#### Report to the Future Melbourne (Planning) Committee

Agenda item 6.5

3 May 2016

Ministerial Planning Referral: TPM-2016-7 582-606 Collins Street. Melbourne

Figure 3 - Applicant submission of daylight penetration possible to through block link

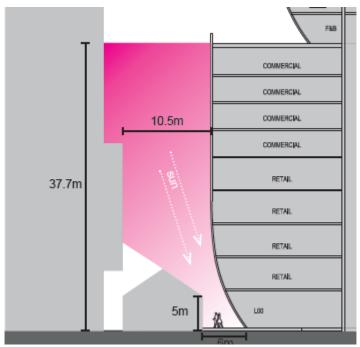
Support is provided in relation to the through block link however it is considered that further refinement and design work is required to ensure that this area has a high level of amenity that is open to the public 24/7. Urban design have noted that 'the resolution of the internal levels relative to the profile of this external ramp is successful, and the stairs to the edge of the gallery space should be exploited further for potential to double as seating perches'. However the success of the through block link as a public space is somewhat linked to the potential for the western lot being redeveloped with a building that would compromise the amenity of the space and elements such as the green wall.

The applicant has noted the client part owns the adjoining land at 608 -610 Collins Street which will ensure that planned amenity of the through block link and the podium commercial space is retained in perpetuity and can be protected and controlled.

City Design have also raised some concern with the location and amenity of the 'Laneway Plaza', or 'Colonnade' (through block link) and have recommended that additional details be provided in relation to the landscaped areas. As such it is recommended that further design work is required which may include the submission of the amended plans and landscaping to ensure a high level of amenity and integration to Collins Street, Francis Street and the ground level of the building.

Figure 4 – ground level wind conditions

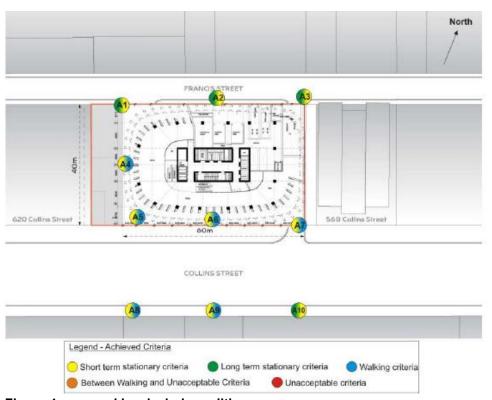
Collins Street is affected by a DDO1 and as such wind conditions should be generally acceptable for stationary long term wind exposure. It has been indicated that this area will achieve short term/walking criteria. It is recommended that additional testing and design work is undertaken to ensure better compliance with the above requirements.

Figure 5 - overshadowing diagram

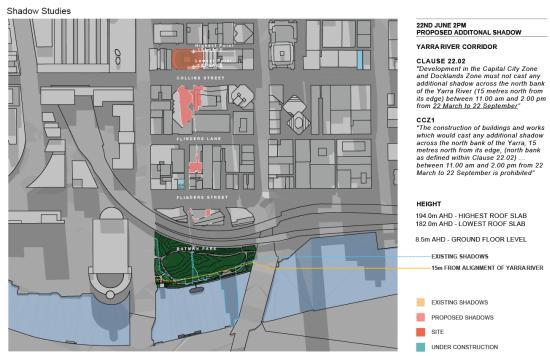
The building has been design to so that it will not overshadow the north bank and will not detrimentally overshadow key public spaces including Batman Park on 22 September between 11.00am and 2.00pm. Importantly, at 22 June the extent of shadow falls within existing shadow of other buildings and is therefore compliant with the requirements of the Capital City Zone and Clause 22.02.

Figure 6 – Cross-section detailing the proposed level of weather protection to Collins Street

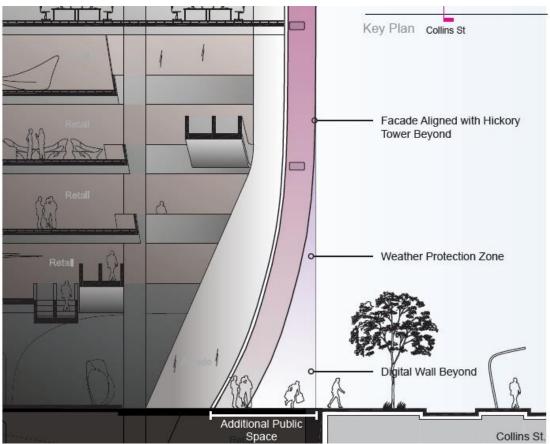
Although the proposed podium overhang provides some weather protection within the property boundary, no weather protection is provided over the public realm (footpath) areas which are one of the highest pedestrian zones in the Central City.

It is considered that insufficient justification has been provided to suggest the particular circumstances do require weather protection along Collins Street. Is therefore recommended that weather protection is provided to be generally consistent with design objectives of the DDO4.

- e. Architectural fins refined to allow greater outlook and light penetration to the residential apartments.
- f. The provision of weather protection over Collins Street.
- g. Refinement of operable glazing to the full western ground floor elevation between the through block link and arts space which minimises physical obstruction between the columns, which could include pivot doors or similar.
- h. Access to all bicycle spaces is convenient and safe.
- i. Any changes required as a result of any recommendations contained in the revised amended environmental wind assessment.
- j. Any changes required as a result of the recommendations within the acoustic report as required by this permit.
- k. Any changes required as a result of the recommendations within the landscape plan as required by this permit.
